## HT802 Firmware Release Note

## FIRMWARE VERSION 1.0.2.7

HT802

### PASSWORD CHANGE CONFIRMATION

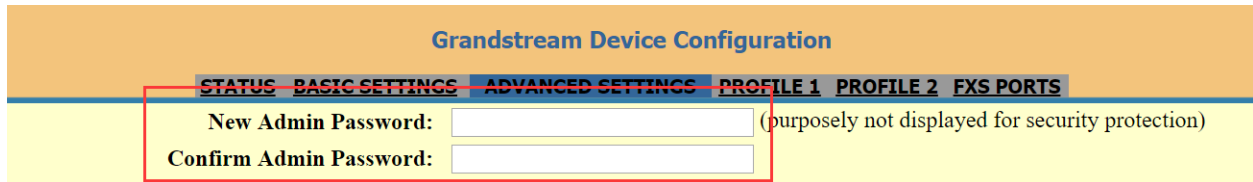
- Added a re-enter box to confirm change user and admin password on web GUI to avoid typo or mistakes. [PASSWORD CHANGE CONFIRMATION]

When change admin password, re-enter the changed password to confirm the new password is correctly entered.

User can find the re-enter confirm box at Web -> Advanced Settings
